**DESIGNER'S RESPONSE TO
STAGE 1 ROAD SAFETY AUDIT
PLAS COCH, WREXHAM**

Report Title	Designer's Response to Stage 1 Road Safety Audit
Date	18.12.2020
Document Reference and Revision	ADL/4171/18C
Prepared By:	ADL Traffic and Highways Engineering Ltd
On behalf of	n/a

Project:	Proposed McDonald's Restaurant, Plas Coch Retail Park, Wrexham
Report Title	Designer's Response to Stage 1 Road Safety Audit
Prepared by:	
Name	R. Green
Position	Associate
Signed	
Organisation	ADL Traffic & Highways Engineering Ltd
Date	18.12.2020
Approved by:	
Name	C. Chapman
Position	Director
Signed	CC
Organisation	ADL Traffic & Highways Engineering Ltd
Date	18.12.2020

PROPOSED PEDESTRIAN CROSSING

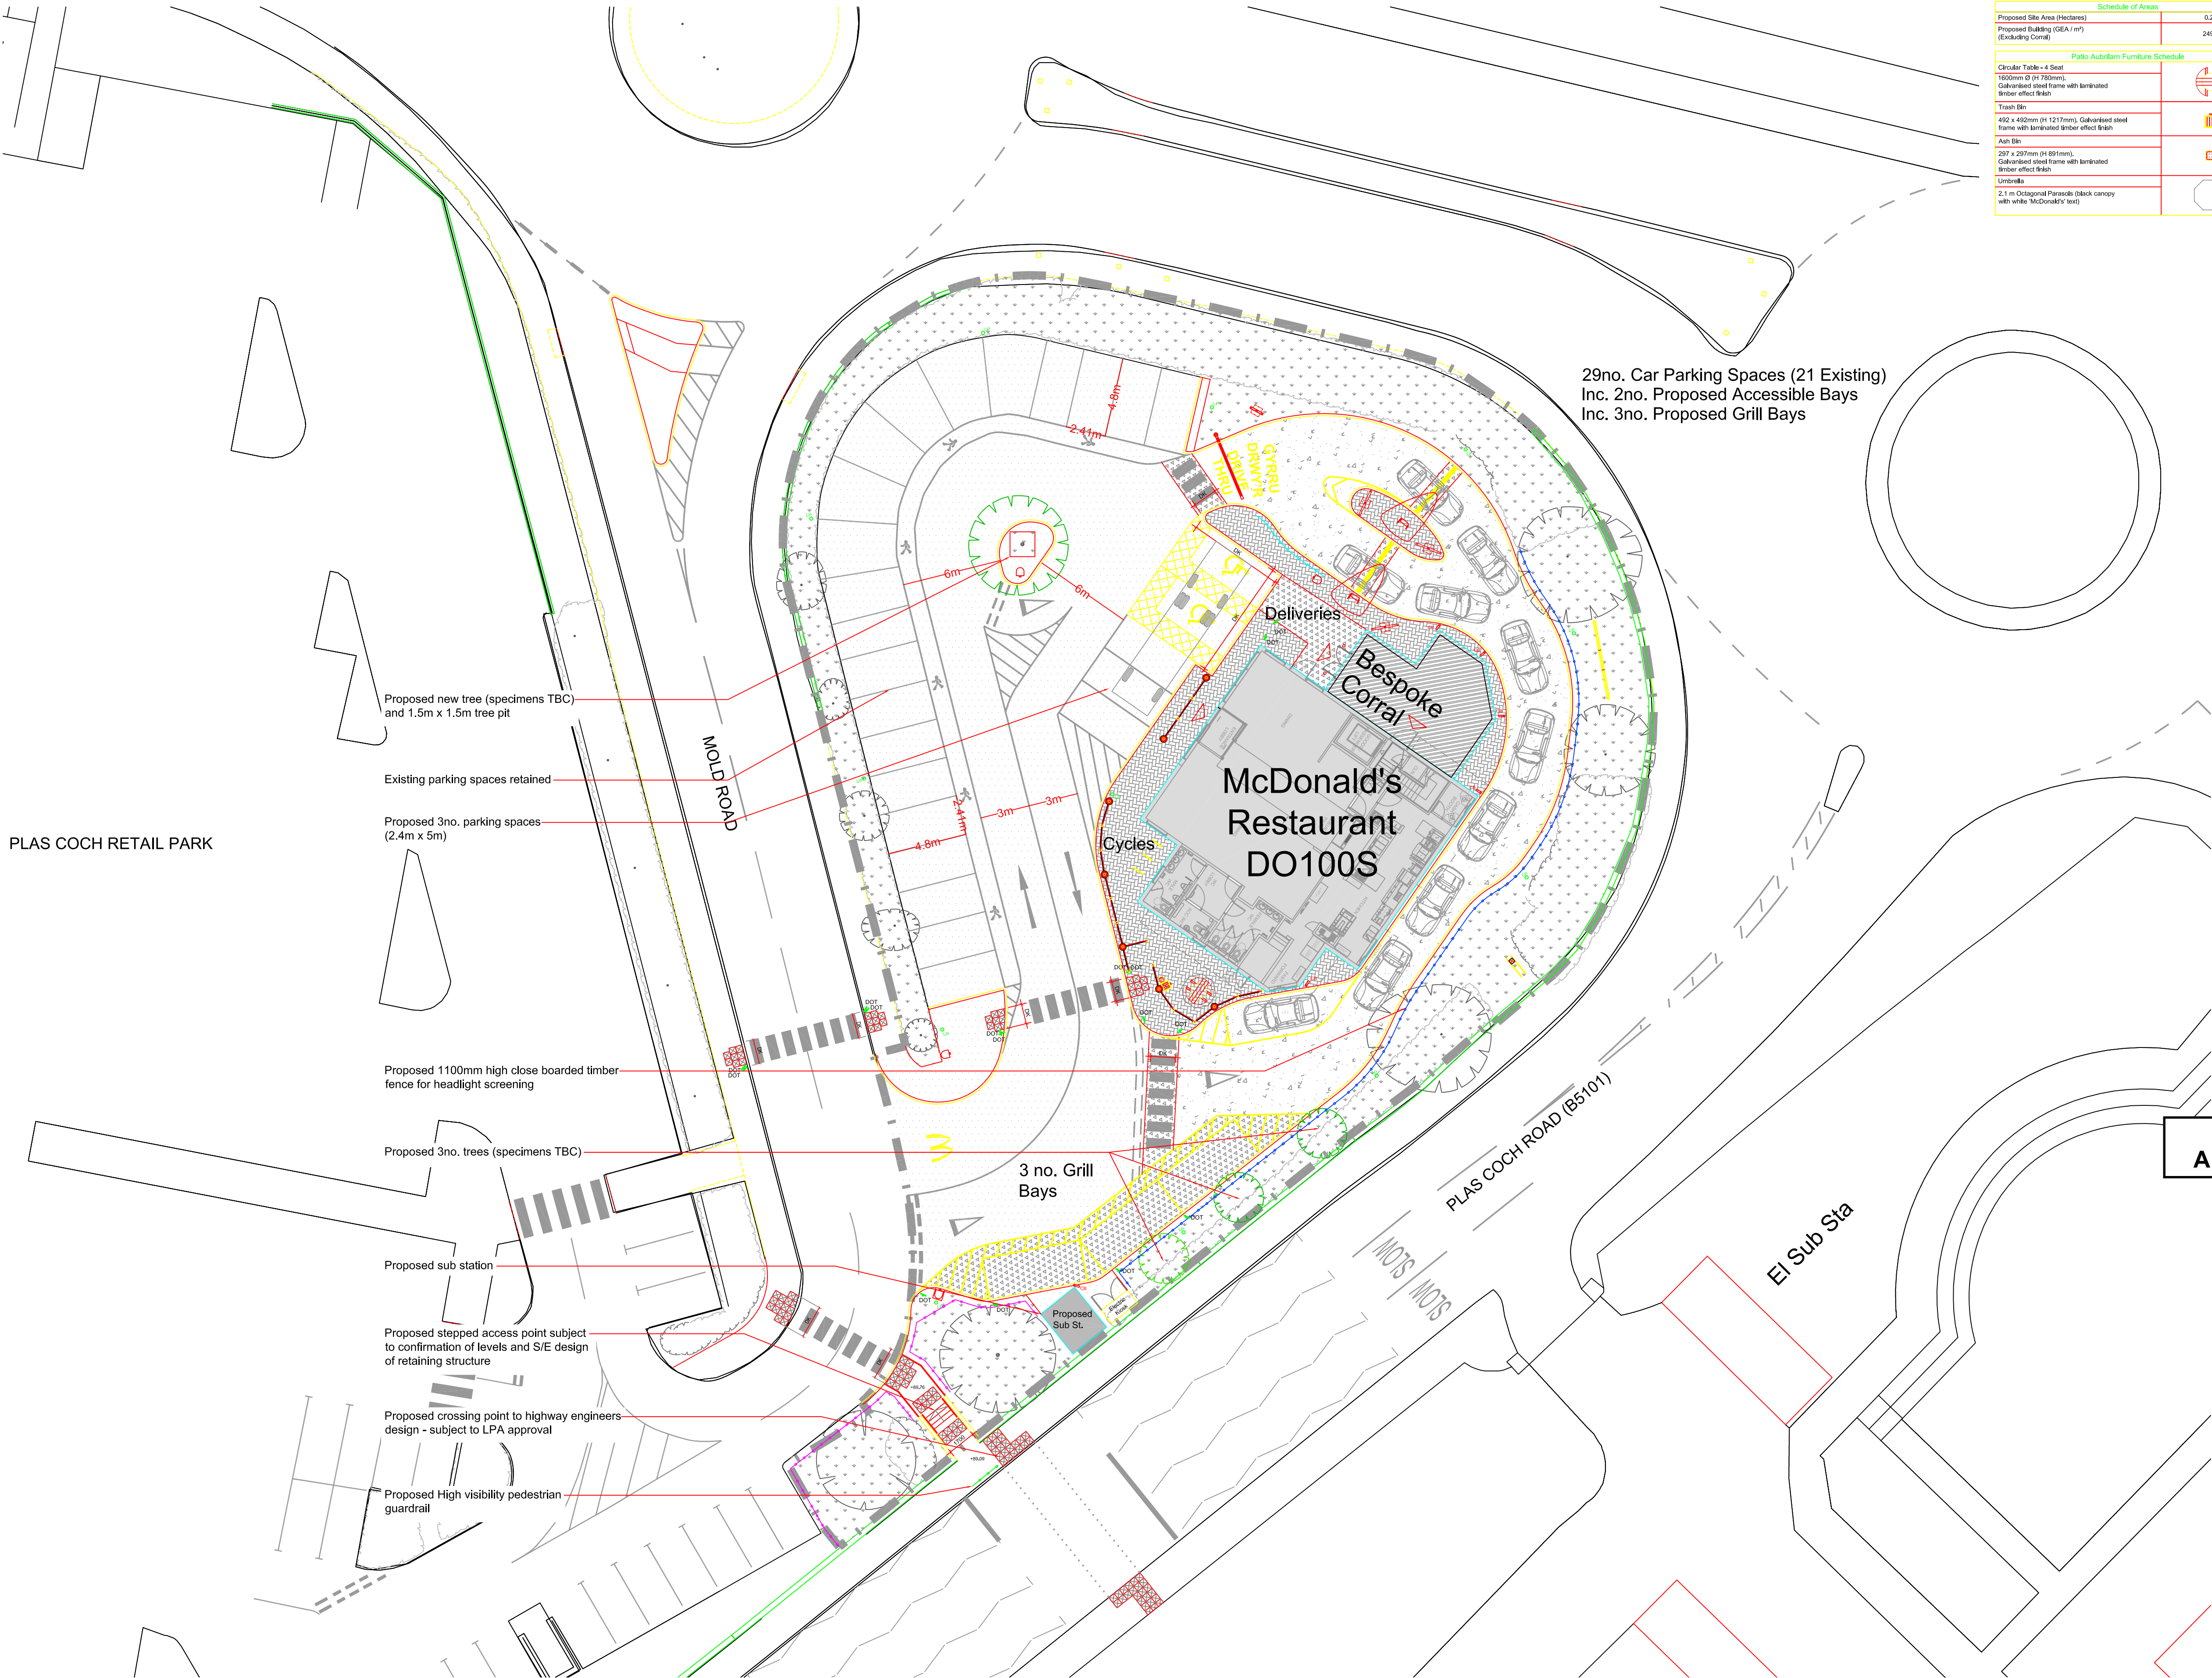
The proposed restaurant will attract customers across Plas Coch Road in the vicinity of the pedestrian entrance. There are no crossing facilities here and the facilities at Plas Coch roundabout are poor. This could result in pedestrians being hit by passing vehicles and injured.

A signalised pedestrian crossing assessment should be carried out and appropriate crossing facilities provided.

A signalised pedestrian crossing is proposed on Plas Coch Road, and can be seen in Appendices 3.0 and 4.0 respectively. The pedestrian crossing facilities at the Plas Coch Road Roundabout are also proposed to be improved in accordance with the Safety Audit recommendations (see item 3.1)
